Response letter for submission of a revision to Wind Energy Science

Daniel Micallef
University of Malta
Department of Environmental Design, Msida, MSD2080, Malta

Date: 03-22-2023

Figure 1: Spatiotemporal contour plots of C_f along the suction side of the blade during the first-half of the last revolution for the NACA00t-4.5/27.5 at $\lambda = 2.5$. Note that the X-axis is along the chord line and $\theta=113°$ corresponds to the blade's $\alpha_{max}= 23°$.

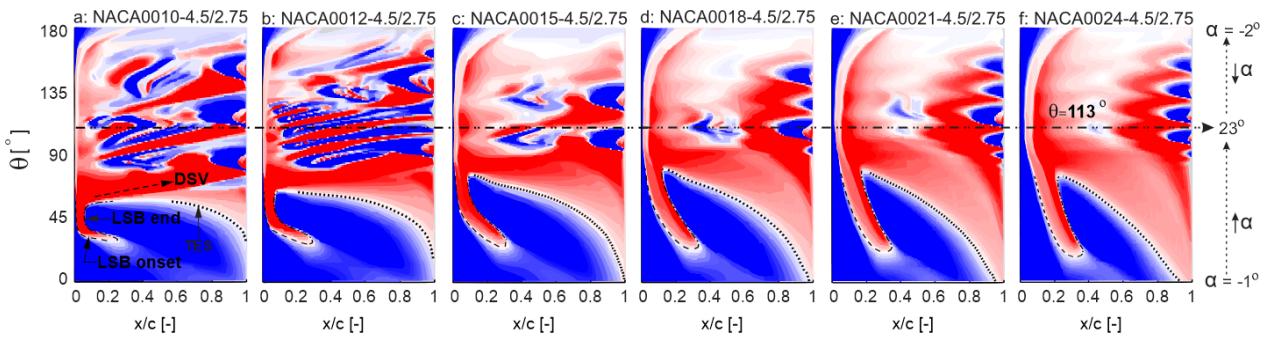
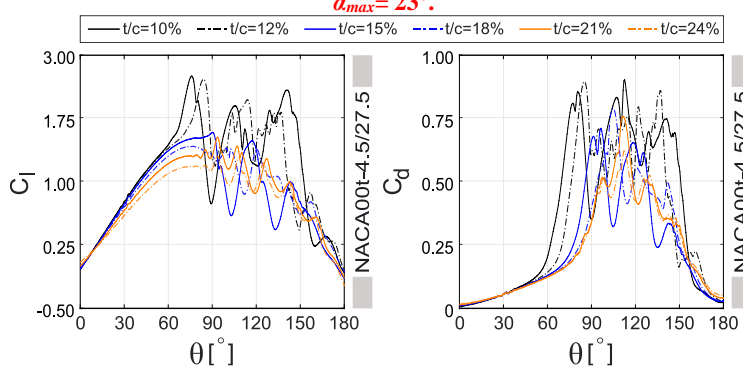
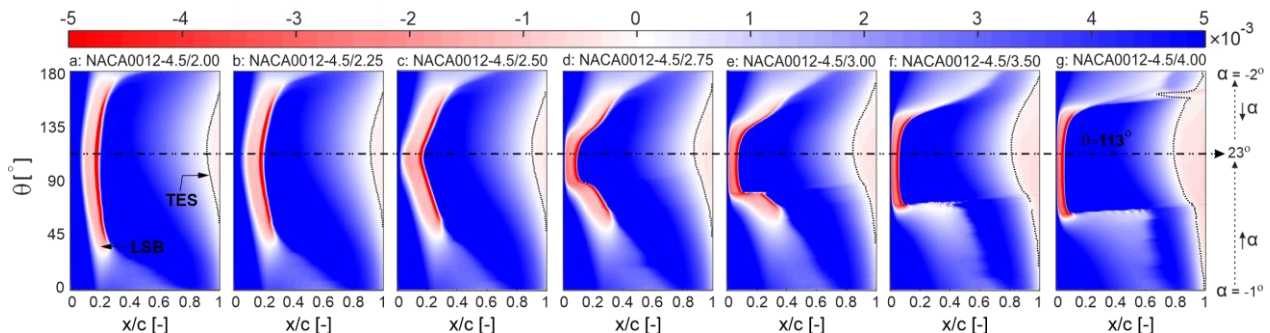
1. The results from the λ dependent blade morphing are valid and provide ample data to underpin the conclusions drawn. A minor detail is that, during the discussion, there is often reference to plots of the aerofoil lift, drag and skin friction coefficients which are not graphically presented. Referring to the behaviour in terms of the coefficients, rather than plots of the coefficients would make the lack of inclusion of these plots less jarring to the reader. Otherwise including a few example plots to show the general behaviour may be of benefit to the reader.

ANSWER:
We appreciate the reviewer's comment. To address your comment, we have incorporated the following figures suggested by the reviewer and modified the corresponding paragraphs in the revised manuscript.

**Figure 2: Impact of t/c on the variations of C_l and C_d versus θ during the first-half of the turbine last revolution for $xt/c = 27.5\%$ with $I = 4.5$ at $\lambda = 2.5$.**

Figure 3: Spatiotemporal contour plots of C_f along the suction side of the turbine blade during the first-half of the last revolution for the NACA0012-4.5/xt at $\lambda = 5.5$. Note that the X-axis is along the chord line and $\theta=113°$ corresponds to the blade's $\alpha_{max}= 23°$.

Figure 4: Spatiotemporal contour plots of C_f along the suction side of the turbine blade during the first-half of the last revolution for the NACA0012-4.5/xt at $\lambda = 5.5$. Note that the X-axis is along the chord line and $\theta=113°$ corresponds to the blade's $\alpha_{max}= 23°$.

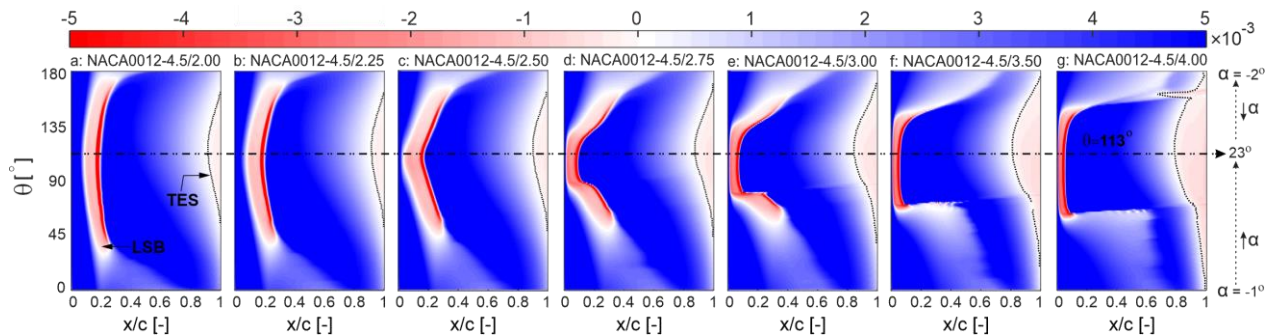
Line 205 page 10: It is hard to visualise this without a plot of the skin friction coefficient.

ANSWER:
We appreciate the reviewer's comment. To address your comment, we have incorporated the following figures suggested by the reviewer and modified the corresponding paragraphs in the revised manuscript.
